Re: Facility Relocation Sprinkler Evaluation  
Puyallup Corporate Park  
2504 East Main  
Puyallup, WA 98372

The scope of this project was for Veltre Engineering to evaluate as a tenant improvement the ability of the existing sprinkler system at RedDot Corporation's new facility to provide an acceptable discharge to protect their current operations. The evaluation includes the impact of the new racking system on the sprinkler performance. The existing facility at 495 Andover Parks East, Tukwila, WA was visited on November 15, 2022, to identify activities, storage arrangements, and commodity classifications. Additionally, the new facility at 2504 East Main Avenue, Puyallup, WA was visited to verify that the primary components of the system that will impact the hydraulic capacity (pump data and size of mains and branch lines) was installed in accordance with the as-built drawings dated 2/9/2022. This evaluation assumes the installation has been accepted by the authority having jurisdiction (AHJ) for Puyallup as a warehouse to be leased based on the design criteria stated in the as-built drawings. The criteria applied in this evaluation is the Washington Building Code (2018 IBC and I

Picture 12 – Resin Beads, Small Bags

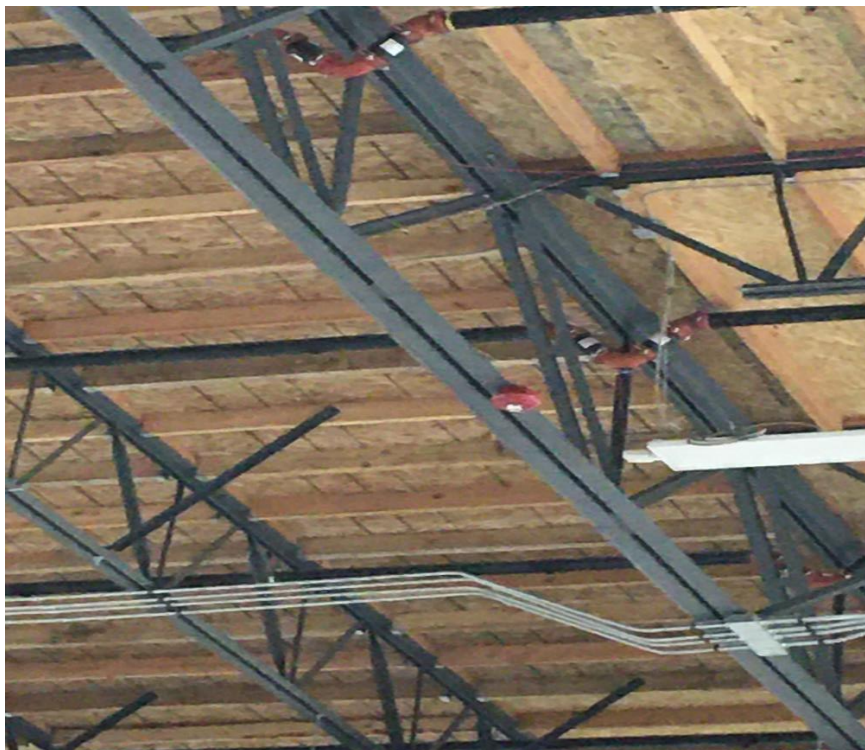
- Wood pallets, up to 8 ft (see picture 9)
- Wood open shipping frames, up to 8 ft
- (Shipping containers) exposed unexpanded Group A plastic, up to 11 ft (see pictures 10 and 11)
- (Bags of ABS resin beads) exposed unexpanded Group A plastic, small bags up to 12 ft and large 4'x4'x4' bags up to 9 ft (see pictures 12 and 13)
- (Rolls of bubble wrap) exposed expanded Group A plastic, up to 8 ft

Picture 15 – Columns

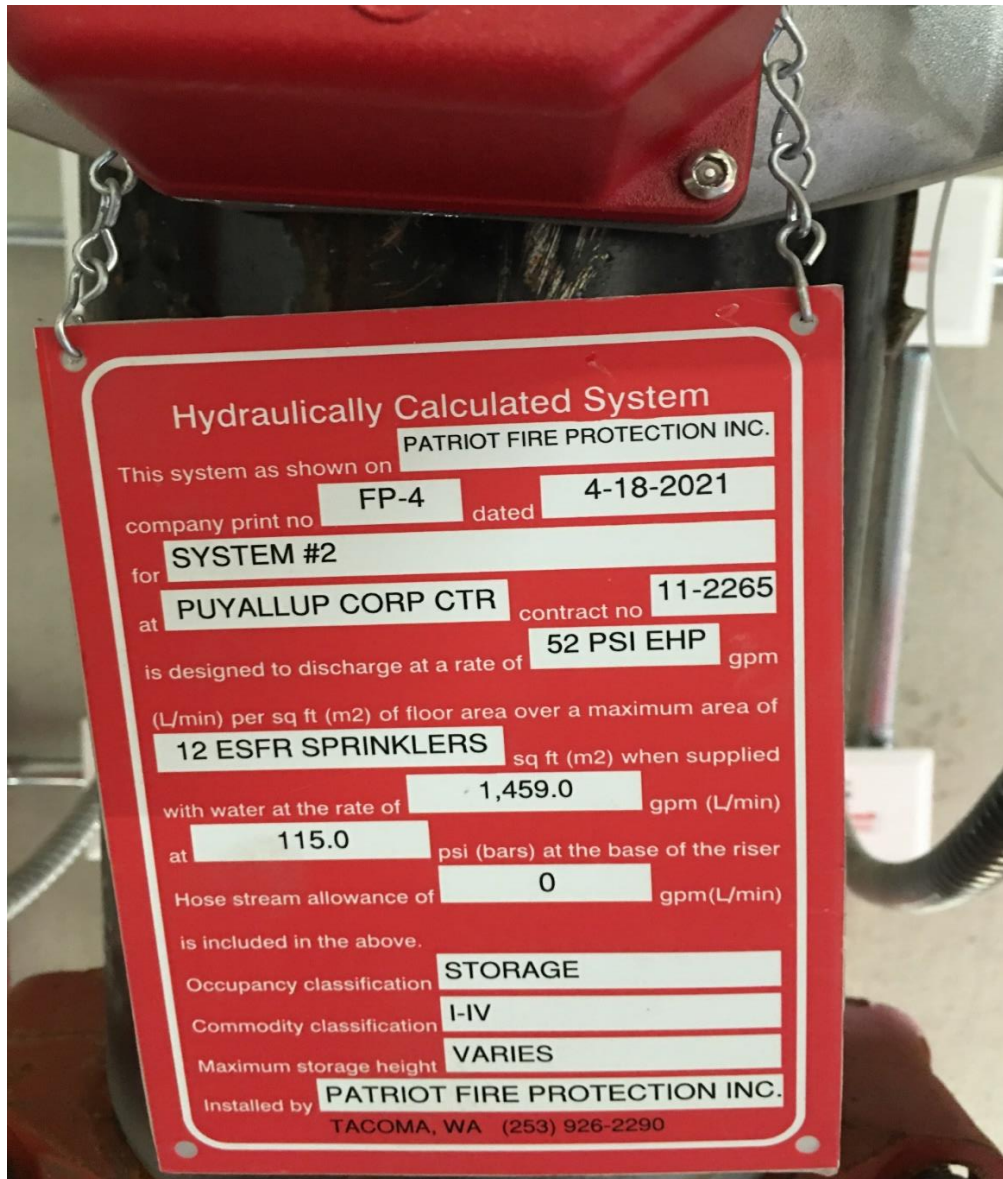
The new facility has a floor plan of 199,225 sf, a maximum ceiling height of 38'4", and a ceiling slope less than 2 in 12. The ceiling consists of plywood with 2x6 joists on 2 ft center classified as combustible obstructed combustion (see picture 14). The wood joists are supported by 2 ft and 3 ft metal trusses with steel columns (without fireproofing) throughout the floor area (see picture 15). The same occupancies groups and functions will apply.

## Hydraulic Calculations by HydraCALC

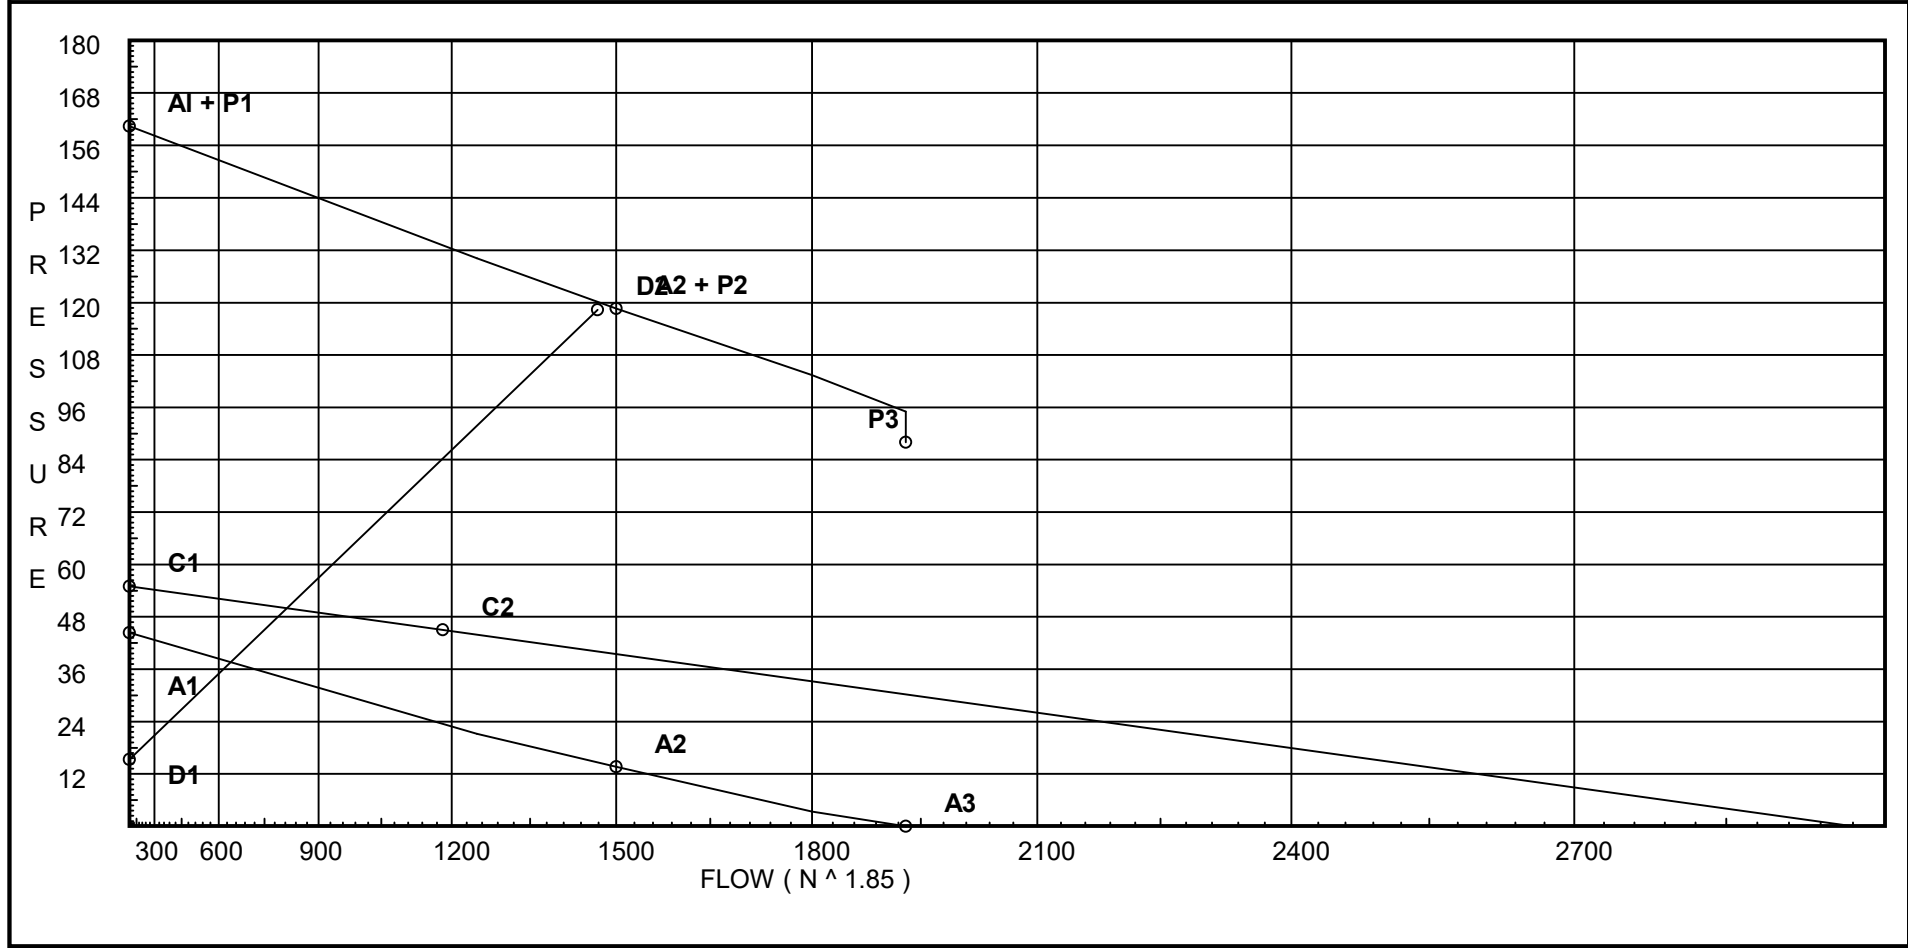
There were no hydraulic calculations submitted with the as-built drawings. The hydraulic data signs indicates a typical demand at the base of the riser to be 1,459 gpm at 115 psi. Veltre Engineering performed a supplemental hydraulic calculation and found the demand at the base of the riser to be 1,468 gpm at 117 psi (see Appendix B).

Figure A – Temperature Ratings Near Unit Heaters

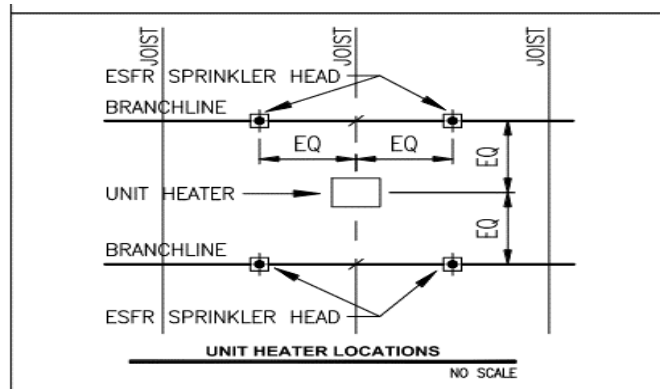
The sprinkler as-built drawings have identified that the sprinklers immediately adjacent to the ceiling unit heaters have an intermediate temperature rating (see Figure A) as required by NFPA 13, paragraph 9.4.2.5. The requirement for intermediate rated sprinklers extends 20 ft out discharge side of the unit

heater in a pie shape area based on a 30-degree angle out from the corner of the unit heater. This would pick-up two to four sprinklers on the next branch line. The second branch line is note addressed on the as-builts. The installing contractor should verify the temperature rating complies with NFPA 13 and update the as-built drawings to reflect it. If sprinklers with an ordinary temperature rating have been installed on the second branch line, the heater discharge could inadvertently activate the sprinklers.
